**1 Products affected**

**3 Detailed description of change**

Product Change Notification					FEU improvement		
owner	creation date	release date	released by	change order no	rev	page	D10-003-795
dislercy	2016-05-02	2017-06-02	nowakfr	2010314	A	1 of 2

**2 Type of change**

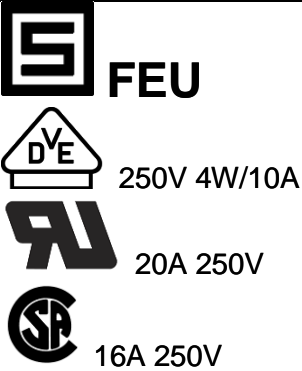
- Change of material
- Modified label
- Change of marking
- Improved voltage rating
- Improved electrical contact

The new materials fulfil the enhanced glow wire requirements according to the updated standard IEC 60127-6:2014 and are free of halogenated flame retardant and red phosphorus.

Old product approval		New product approval	
<b>UL 512</b> 20A, 250V <b>CSA C22.2 no. 39</b> 16A, 250V <b>IEC 60127-6 (VDE)</b> 4W, 10A, 250V AC		<b>UL 4248-1 - CSA C22.2 no. 4248.1</b> 20A, 600V AC or DC  <b>IEC 60127-6:2014 (VDE)</b> 4W, 10A, 250V AC	
Old label		New label
